Solicitation No. 3450035790

Amendment No. 1

**BRYAN COUNTY
MAINTENANCE FACILITY**

REVISION SUMMARY – ADDENDUM #01

EVAPORATION POND NOTES:

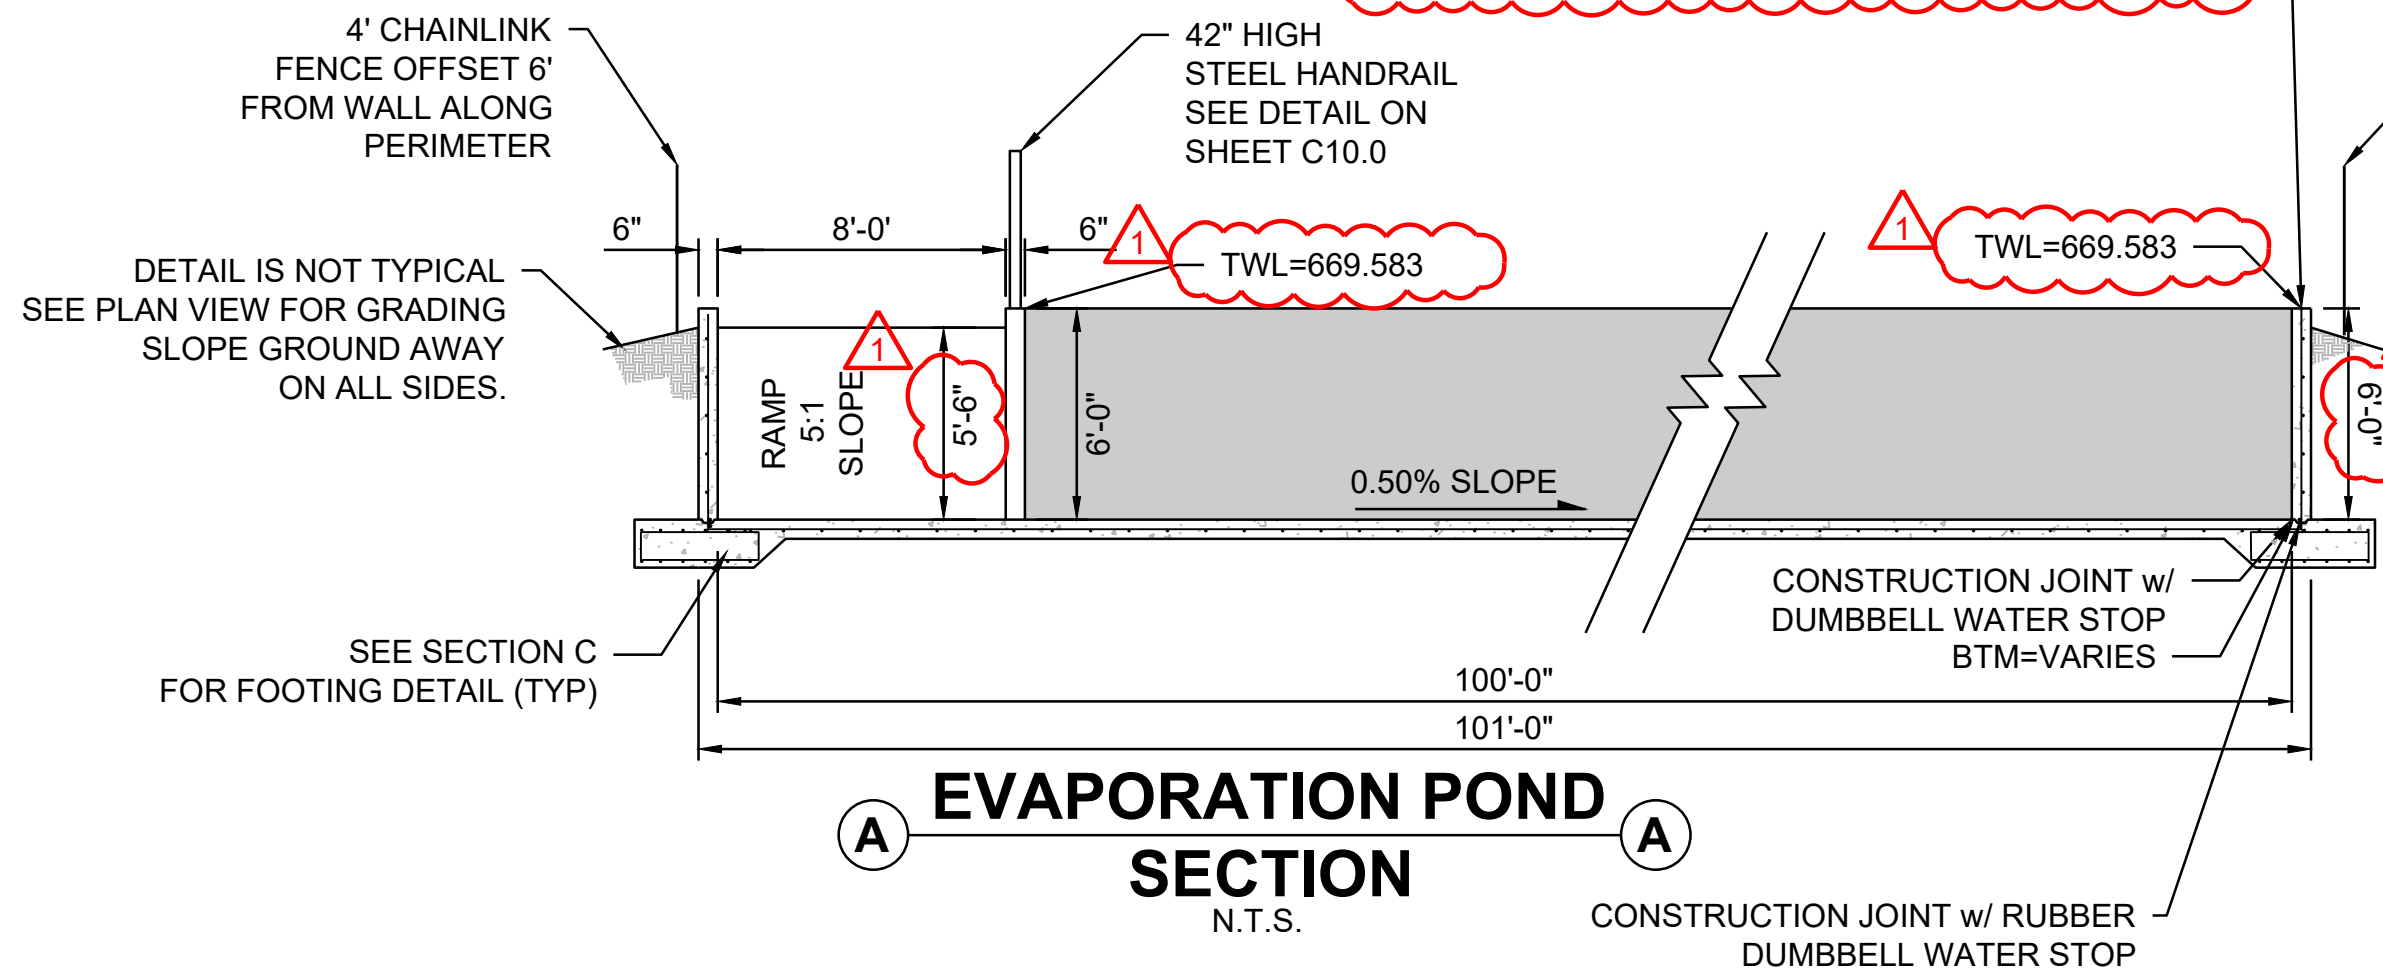
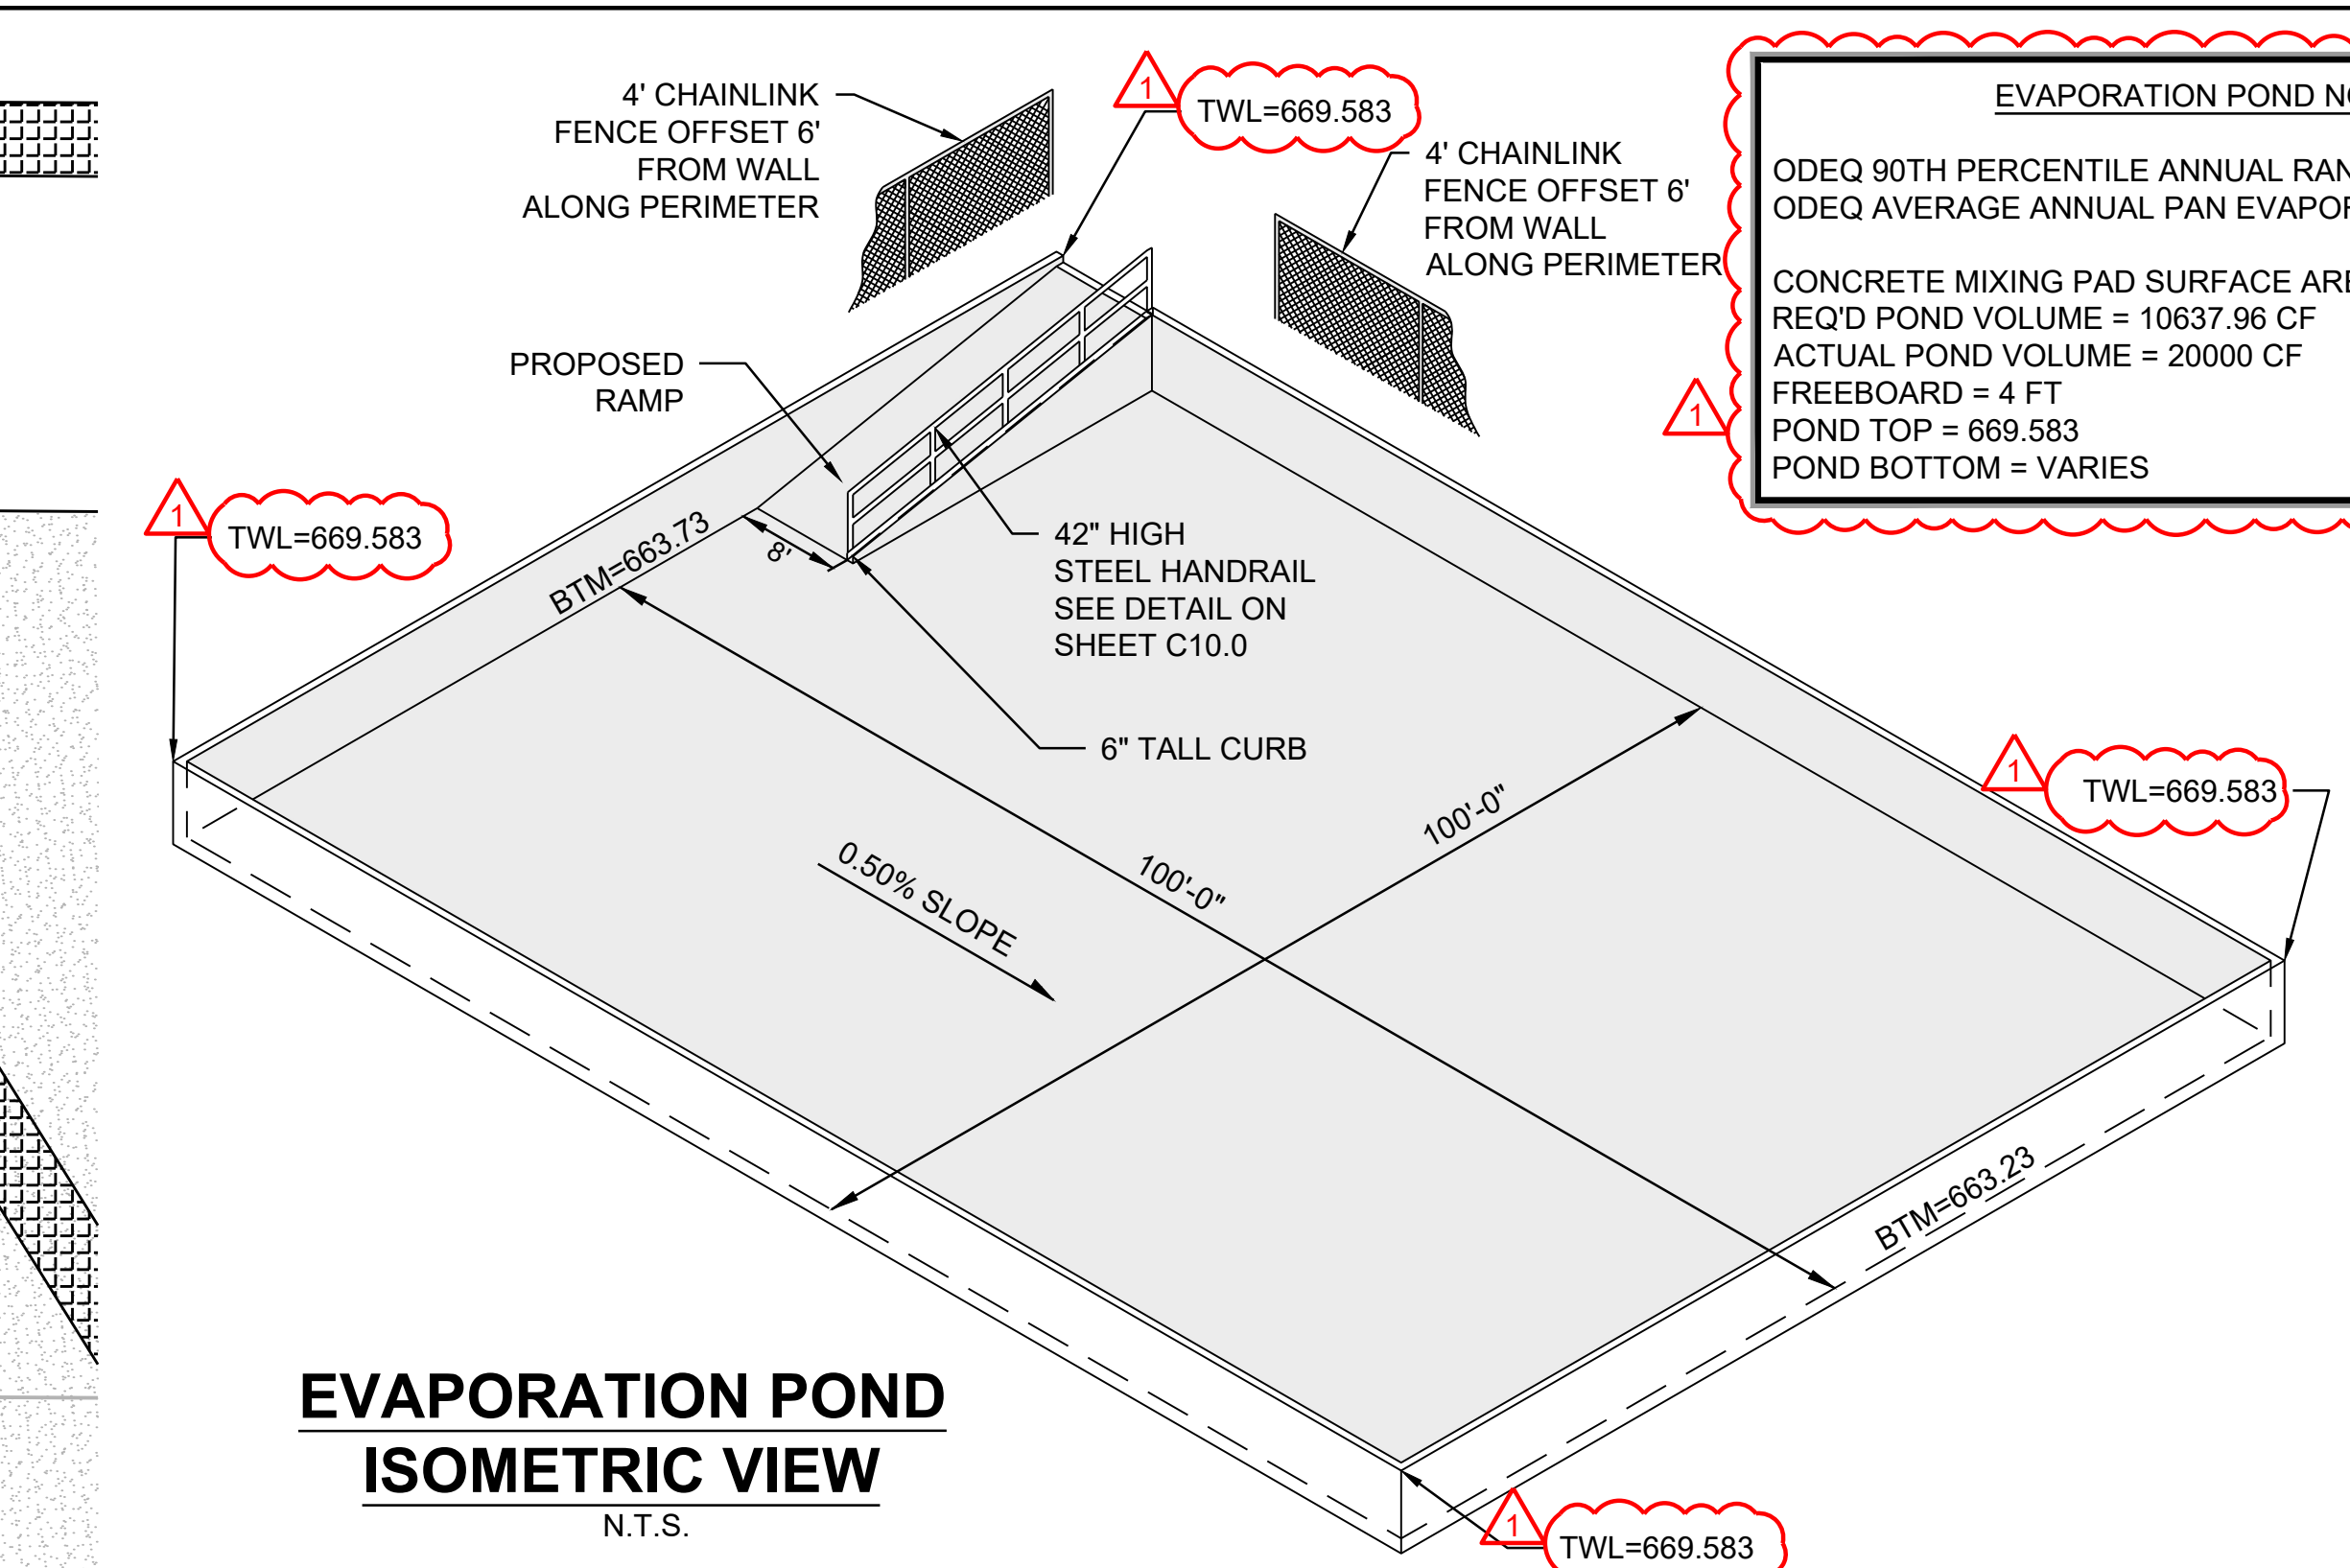
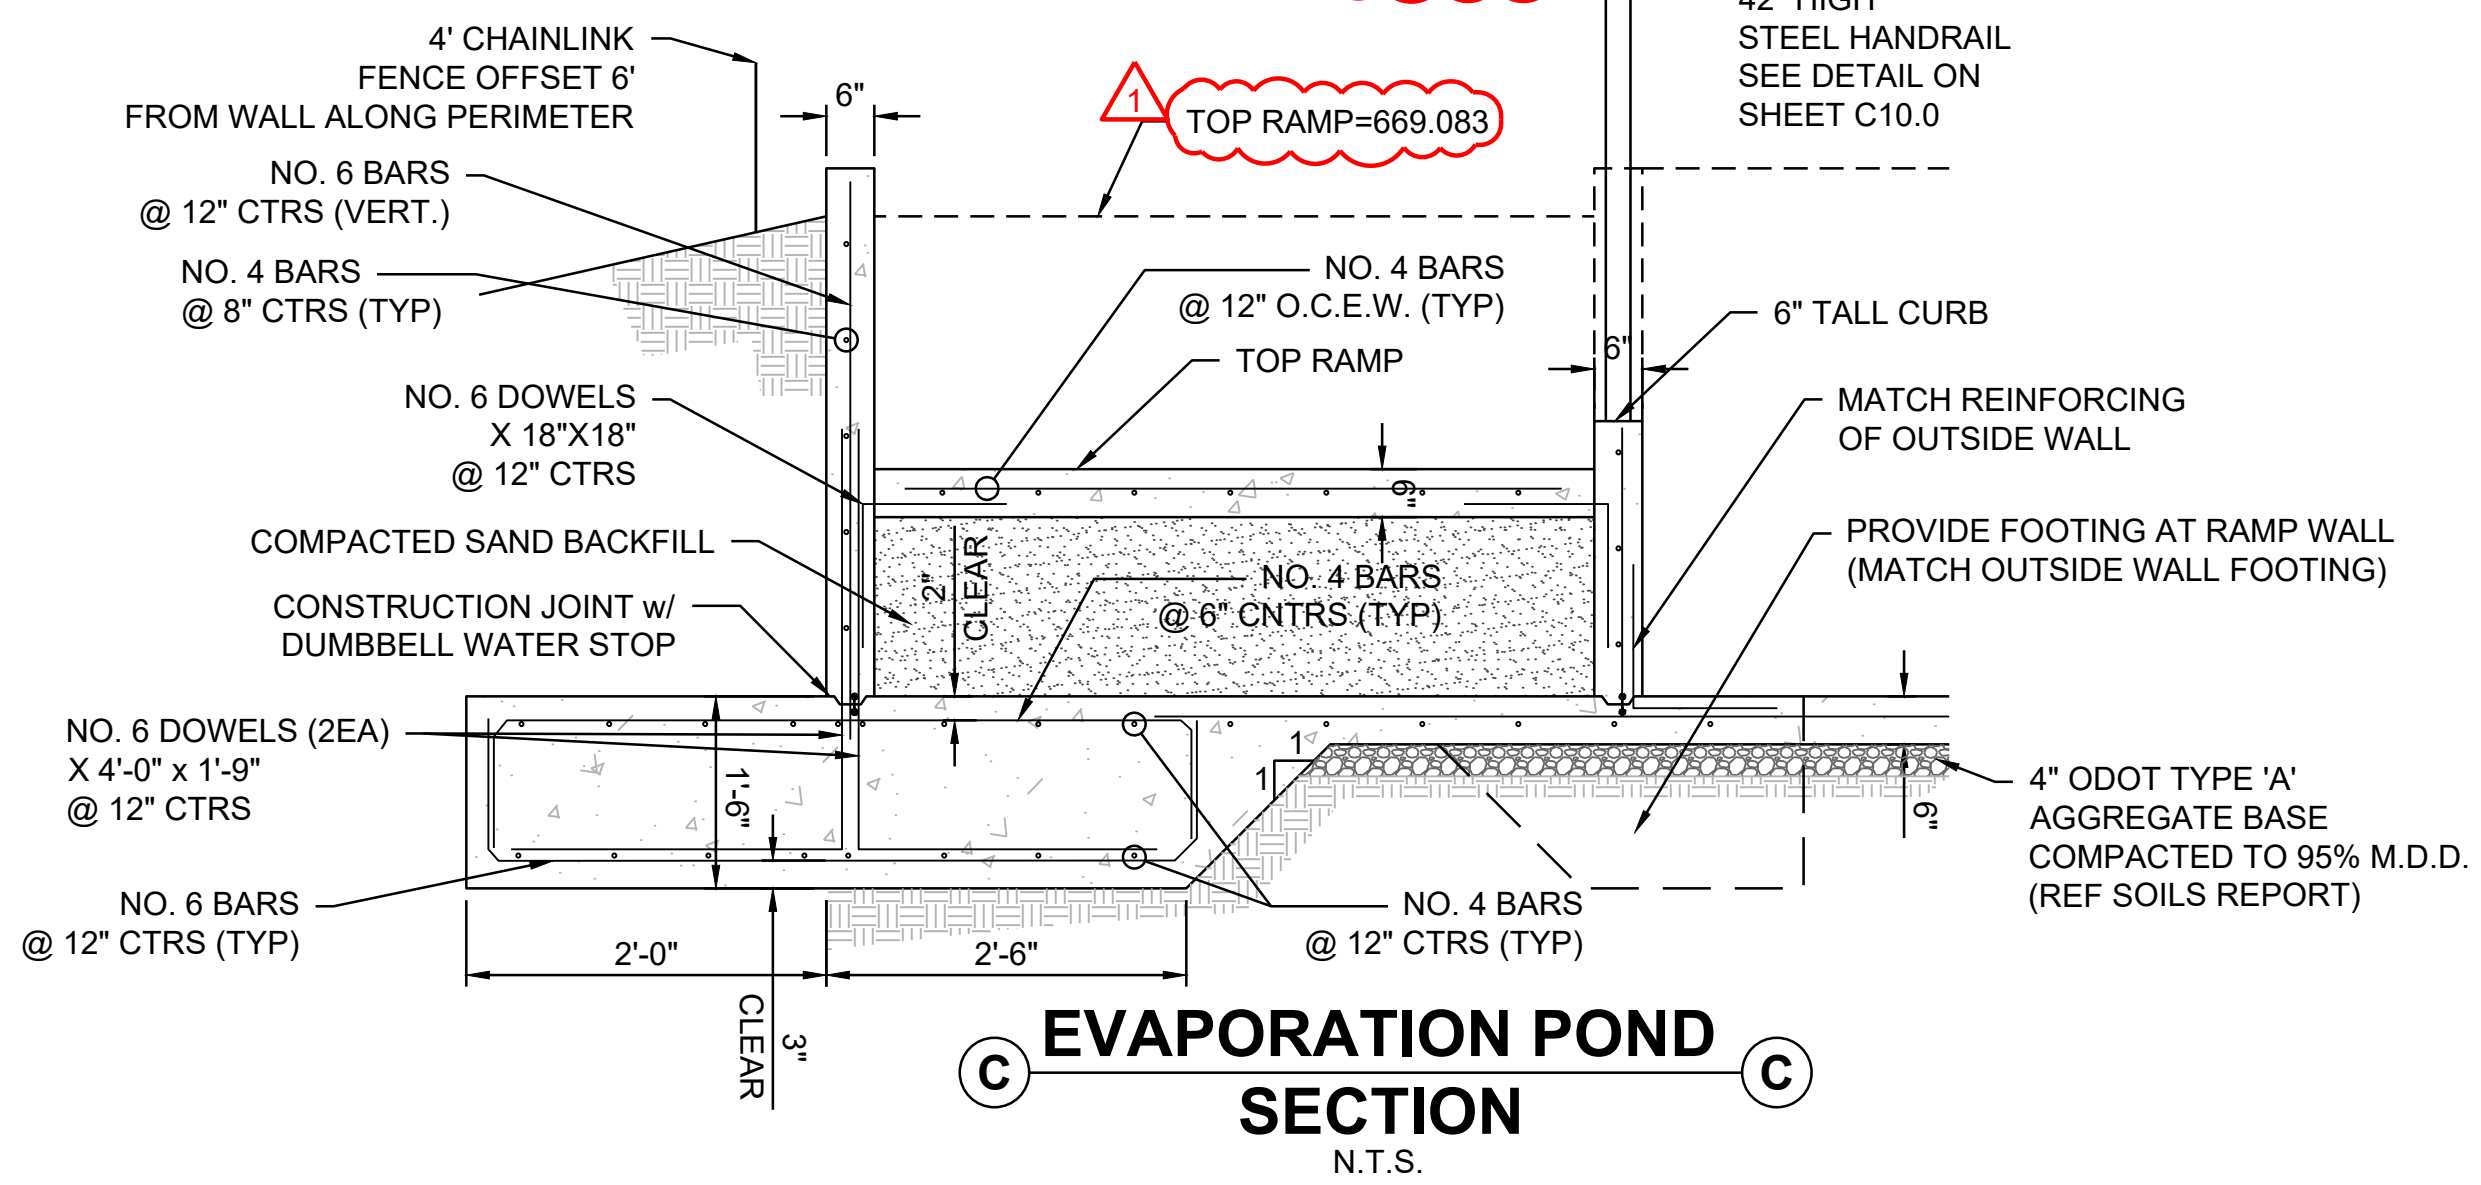
Q 8: Dimensions indicate a 10,000-sf pond. The pond notes indicate a surface area of 3,600 square feet. Please clarify. (C8.0)

2. UPDATED DESIGN NOTES FOR EVAPORATION POND.

A 8: Pond is 10,000 sf. C8.0 detail will be updated to correct pond information.

CONCRETE MIXING PAD SURFACE AREA = 3600 SF
REQ'D POND VOLUME = 10637.96 CF
ACTUAL POND VOLUME = 20000 CF
FREEBOARD = 4 FT
POND TOP = 669.583
POND BOTTOM = VARIES
